From: [Green, Frank](#)
To: [Daly, Keith](#);
Subject: FW: Contract 8078 - Current Water Level on Columbia River
Date: Monday, February 07, 2011 8:45:06 AM
Attachments: [RIVERLEVEL,Weekof1-30-11.jpg](#)

Consider this RFI 5

From: "Vernon Uy" <vernonu@americanconstco.com>
Sent: Sunday, February 06, 2011 7:22 PM
To: "Mark Degenhart - WSDOT" <degenhartm@columbiarivercrossing.org>, "Frank Green - WSDOT" <greenf@columbiarivercrossing.org>
Subject: Contract 8078 - Current Water Level on Columbia River

USGS 14144700 COLUMBIA RIVER AT VANCOUVER, WA

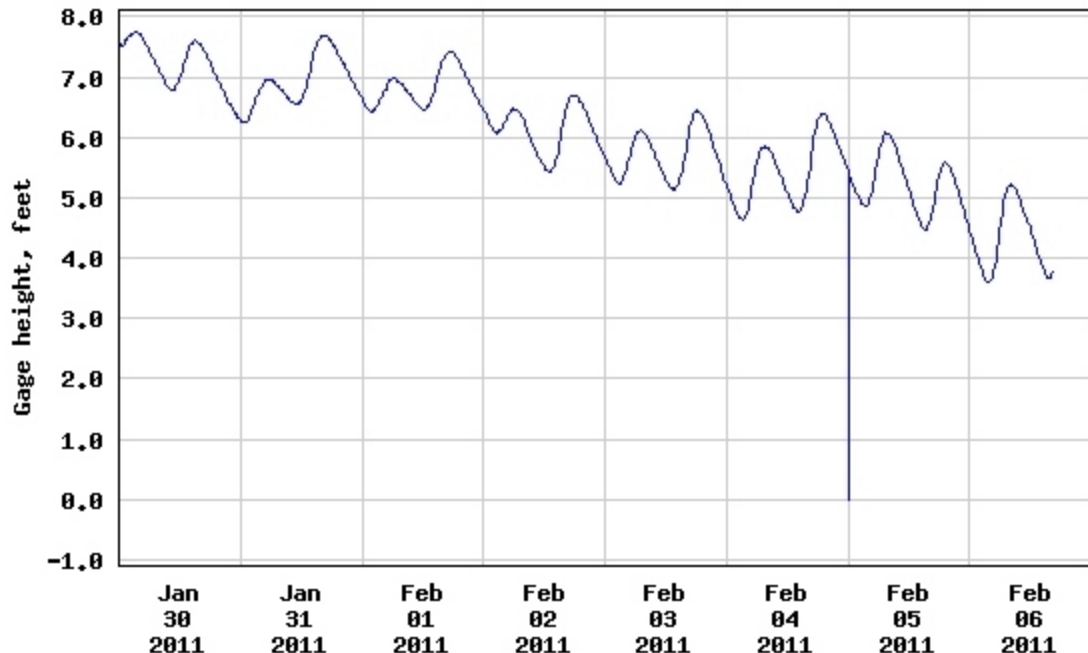
I noticed on Friday (2/4) that the water level on the river is only between 6.5' and 5'. This translates to EL +11.8' and EL +10.3' (NAVD88 datum). This is quite a bit lower than the "high river level" of EL +21.2' (as shown on Plan Sheet ND1).

Attached is a chart that shows water level on the river last week. You need to add 5.28' to each value to convert to NAVD88 datum.

Conclusion: There will not be enough water depth (assuming mudline elevations of EL -21' and -25' are correct) to use all 7 bubble rings (unconfined system). Looks like only a total of 5 or 6 bubble rings will be needed.

Furthermore, fewer bubble rings mean fewer compressors are required to supply the system. Three (3) 1600-cfm compressors will be enough to provide air for up to 6 bubble rings (1600cfm x 3 = 4,800cfm or 800cfm minimum per bubble ring).

Since the water level is lower, there will be one (or two) bubble rings not in the water. We still need the setup to include all of the bubble rings shown in the plans.
